UNITED STATES
DEPARTMENT OF THE INTERIOR
BUREAU OF LAND MANAGEMENT**SUNDRY NOTICES AND REPORTS ON WELLS**
*Do not use this form for proposals to drill or to re-enter an abandoned well. Use form 3160-3 (APD) for such proposals.*FORM APPROVED
OMB NO. 1004-0135
Expires: July 31, 20105. Lease Serial No.
NMLC031670A

7. If Unit or CA/Agreement, Name and/or No.
892000321E8. Well Name and No.
SEMU 289. API Well No.
30-025-07815-00-S110. Field and Pool, or Exploratory
SKAGGS11. County or Parish, and State
LEA COUNTY, NM**SUBMIT IN TRIPLICATE - Other instructions on reverse side.**

SEMU-28W: Casing Repair
API# 30-025-07815
Casing Repair and RTI

Conditions of Approval

Proposed Rod and Tubing Configuration SEMU 028

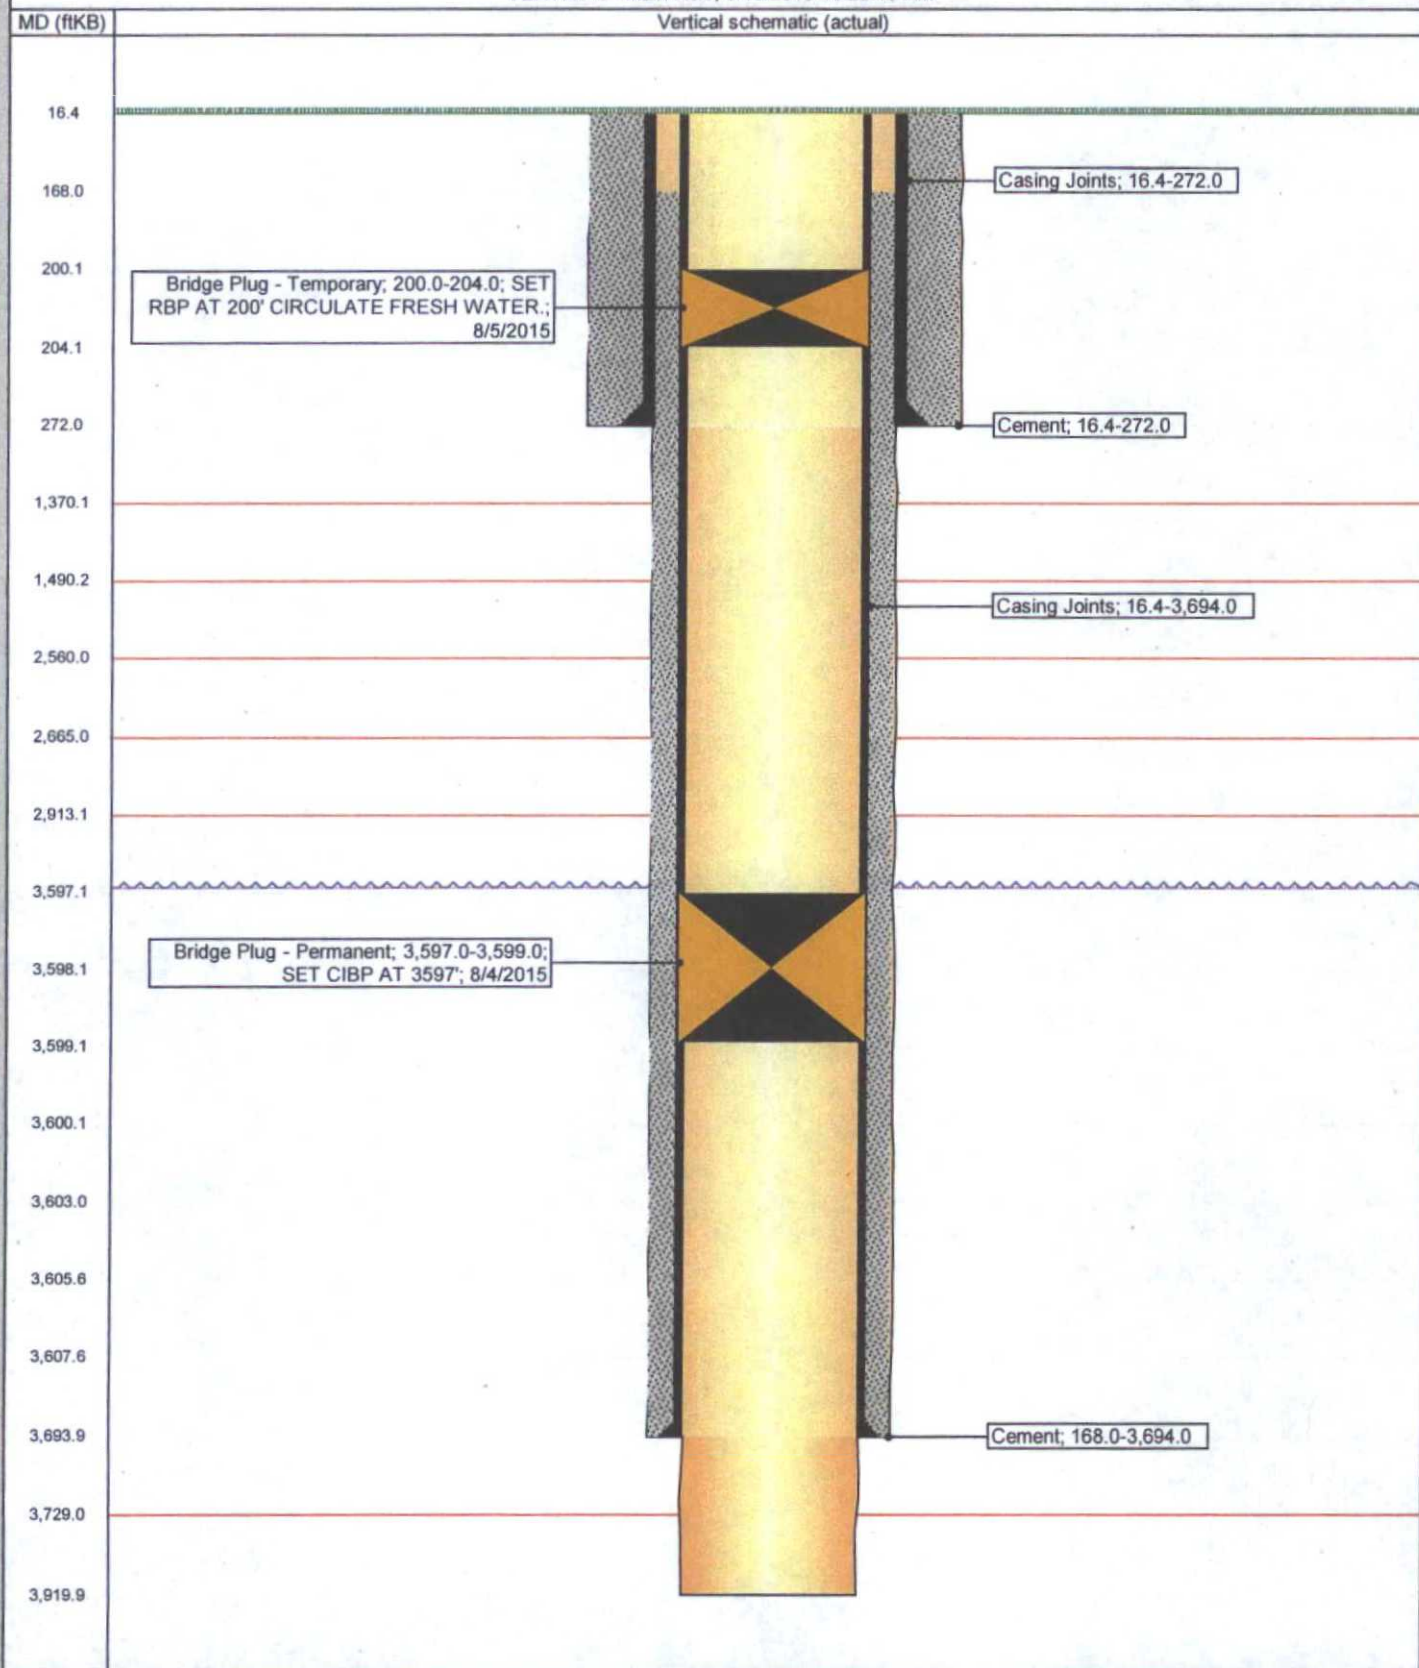
2. Before casing or a liner is added, replaced, or repaired prior BLM approval of the design is required. Use notice of intent Form 3160-5.
3. **This surface repair of the 9 5/8" and 7" csqs requires the replacing casing(s) to be of equal size and equal or improved weight and grade. Excavate surface soil around the wellhead and below the leaks a distance that will expose the 9 5/8" csg cement top and permit entry and access to the top coupling(s). The precautions of a confined entry permit with consideration for adequate side shoring are necessary. Replace the csg and wellheads from the first encountered coupling(s) below the damaged portions. Protect the exposed external csg surface with protective wrapping and/or cement.**

10. After removing RBP, **perform a charted casing integrity test of 800psig minimum against the CIBP at 3597 set 08/05/2015. Document the pressure test on a one hour full rotation calibrated (within 6 months) recorder chart registering within 25 to 85 per cent of its full range. Verify all annular casing vents are plumbed to the surface and open during this**

11. **Provide BLM with an electronic copy (Adobe Acrobat Document) cement bond log record from 3580 or below to top of cement taken with 0psig casing pressure. The CBL may be attached to a pswartz@blm.gov email. The CFO BLM on call engineer may be reached at 575-706-2779.**
